## **Development Facilitation Team (DFT) – Review Comments**

**DRB Project No: PR-2020-003484 Date: 10/25/2023 Agenda Item: #3 Zone Atlas Page: E-10**

**Application For: SD-2023-00048 – PRELIMINARY PLAT (DHO)**

**Project Name:** 6341 Mojave St NW

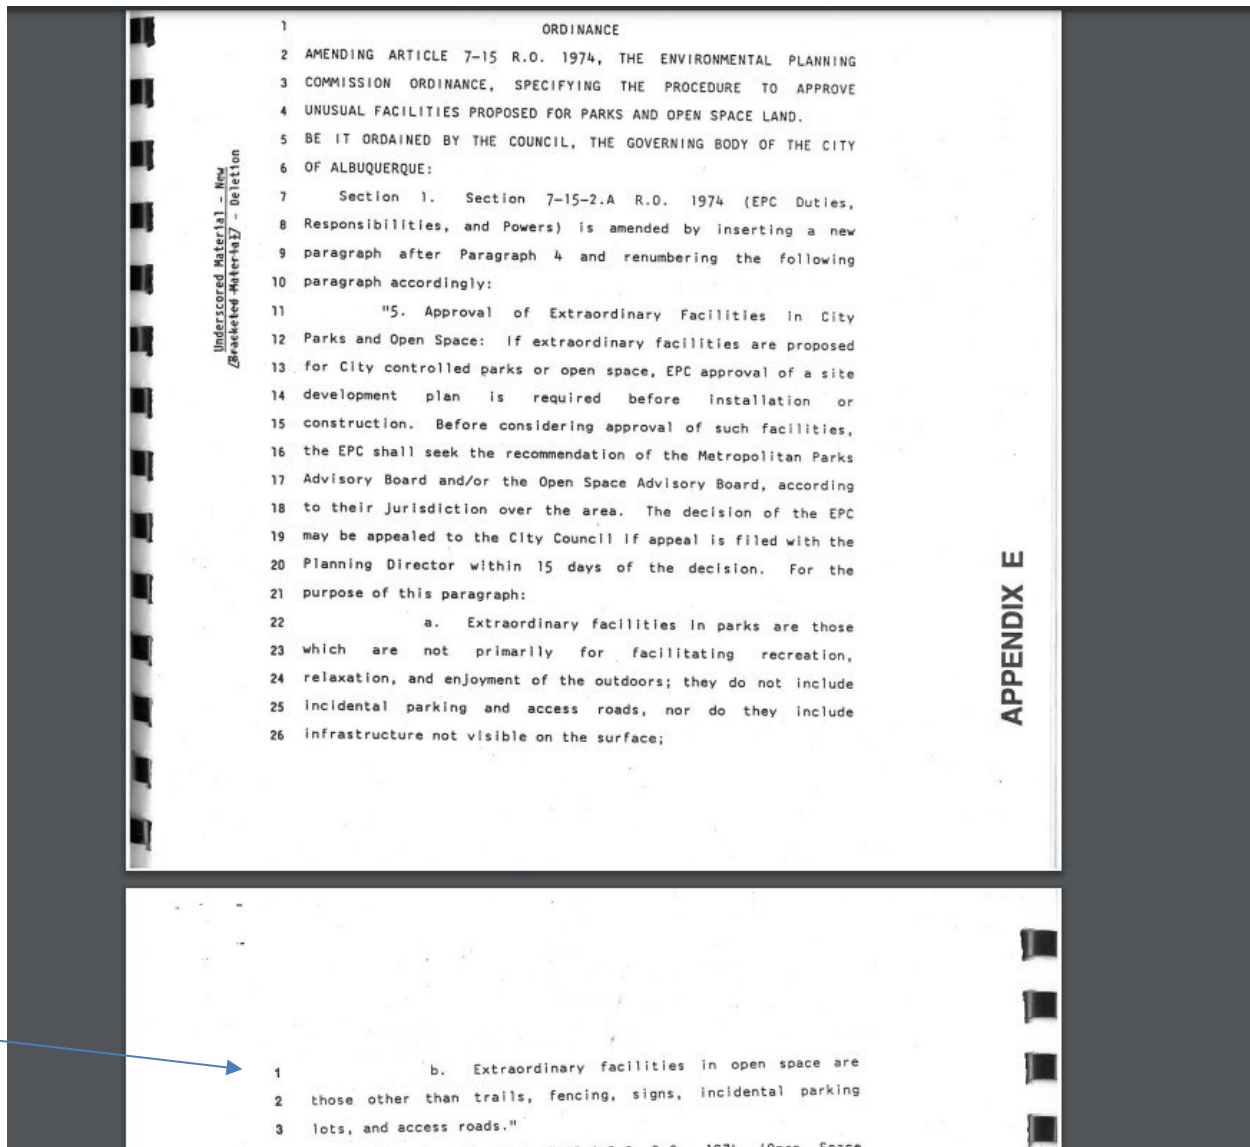
- **Updated 6.28.23:** Planning staff, Open Space Staff, NPS Staff, the agent and the applicant did a field visit on 6.15.23. It was clarified in the field visit that the connection to the sewer line could be a small disturbance if a 6-8 feet wide trench extending 6-8 feet into PNM. The only visible part would be a manhole and there are two similar manholes in the corridor. The other change reviewed was if the drainage pond were to overflow into the PNM land, then it would be a sheet of water rather than an outflow. This seemed to be more acceptable to NPS and City Open Space.
- **Processes required for approval by the National Park Service and City Open Space remain undefined.**

A new issue was raised when Parks and Recreation identified that the Facility Plan for Major Public Open Space defines infrastructure, even if not visible on the ground, as an 'Extraordinary Facility' (see excerpt below) Under this interpretation, the subdivision technically must wait for approval by the Open Space Advisory Board and the Environmental Planning Commission.

PRELIMINARY PLAT FOR  
 MOJAVE RIDGE SUBDIVISION  
 (A REPLAT OF LOTS 2 & 3, BLOCK 1,  
 UNIT 3, VOLCANO CLIFFS SUBDIVISION  
 WITHIN  
 SECTION 27,  
 TOWNSHIP 11 NORTH, RANGE 2 EAST, N.M.  
 CITY OF ALBUQUERQUE  
 BERNALILLO COUNTY, NEW MEXICO  
 JANUARY, 2023

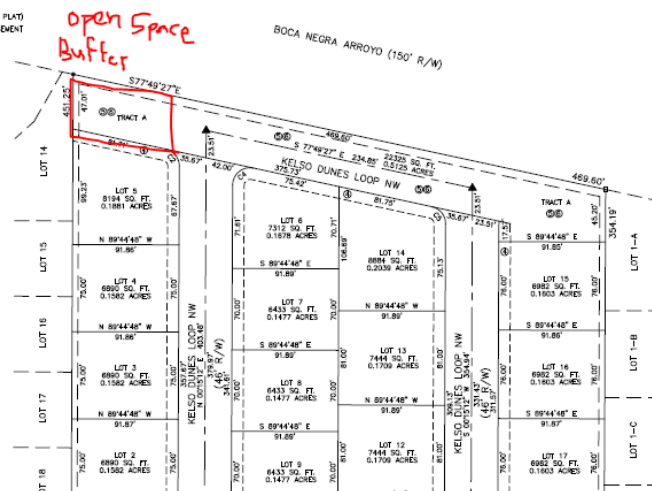
- **Updated 10.23.23** 5-2 (J)(2)(a) Lot 5 is abutting the Boca Negra arroyo. **Applicant has been told multiple times that the Open Space buffer needs to be a separate tract with a note to the plat indicating that the 45 feet buffer abutting the Petroglyph National Monument must have plant approval and location per the Open Space Superintendent.**

**3-6(E)(3) Building and Structure Height**

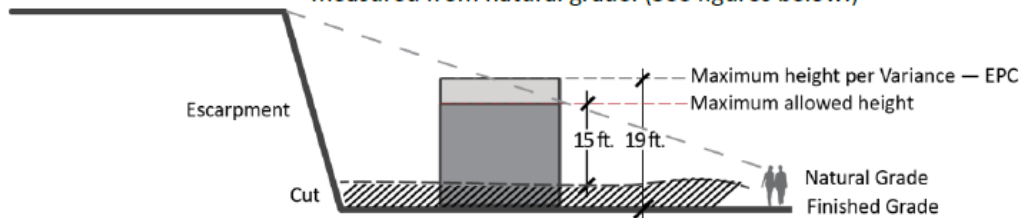
**IDO 3-6(E) The parcels are in the VPO-2 Height Restricted Sub Area. Identify the allowable structure height vis a vis grading plan. 'Building and/or structure height shall not exceed 15 feet, as measured from natural grade.'**

**3-6(E)(3)(a) Building and/or structure height shall not exceed 15 feet, as measured from natural grade. (See figures below.)**

- ✓ The applicant has shown height measurements from finished grade and natural grade and established maximum building heights that do not exceed 15 feet.
